**REQUEST**

Current Zoning: R-5 (single family residential)  
Proposed Zoning: UR-3 CD (urban residential, conditional)

Approximately 0.52 acres located at 1118 Parkwood Avenue, adjacent to Pegram Street in the Belmont neighborhood.

## PLANNING STAFF REVIEW

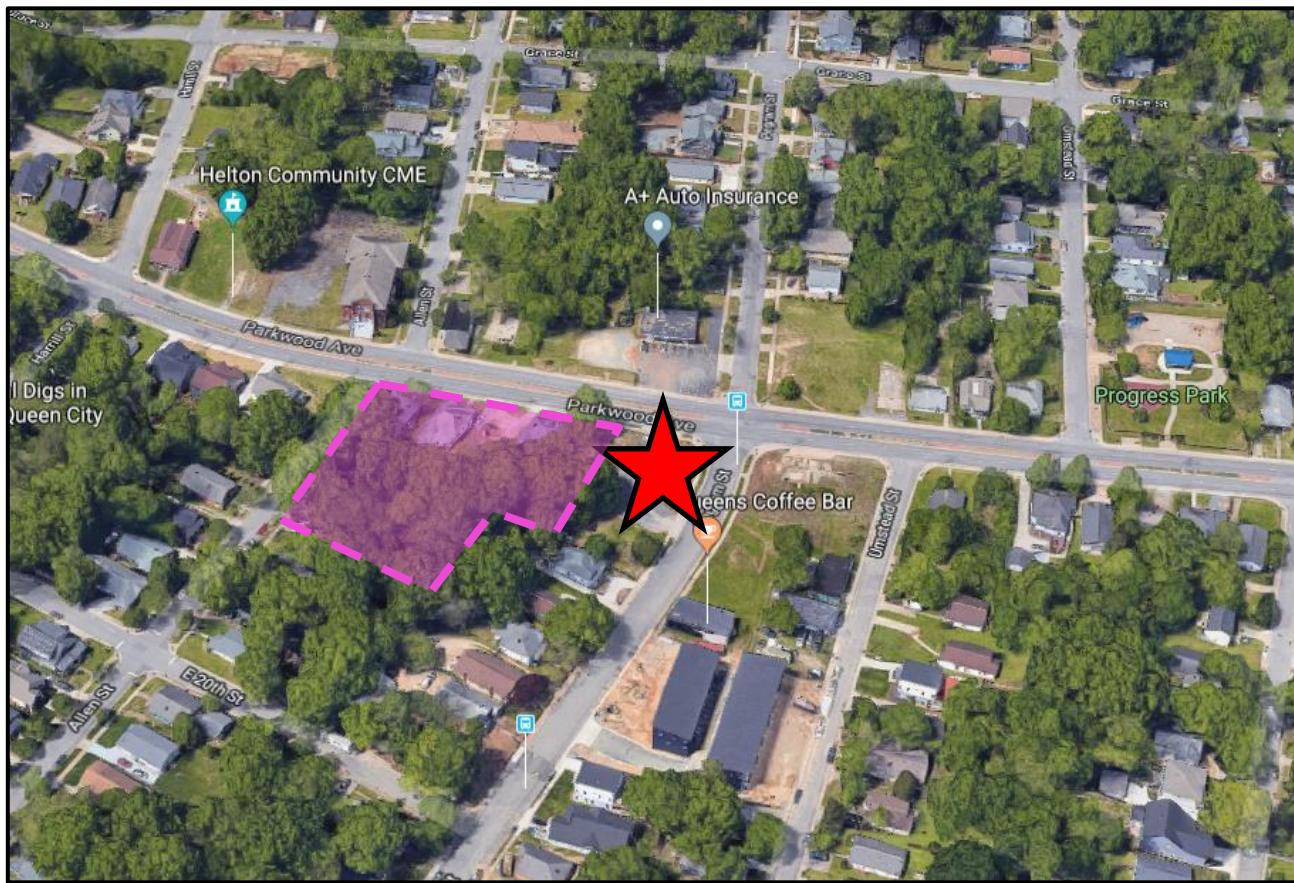
- The construction of one multi-family building with no more than 17 dwelling units containing at least three affordable rate units.
- Commits to a limit of 20,000 SF for the total floor area of the structure.
- Commits to a maximum height of 42 feet.
- Provides access off Pegram Street.
- Commits to replacing existing CATS bench and waiting pad with an ADA compliant pad per CATS specifications.
- Commits to multiple architectural standards including preferred building materials, articulated facades, and multiple roof lines.
- Provides full cut-off type lighting excluding decorative accent lighting.

1. Commit to installing the inter-parcel access point shown on site plan revision dated 1/15/2020.
2. The proposed structure should be replaced with single family homes or a structure which does not exceed the recommended residential density for the subject property.
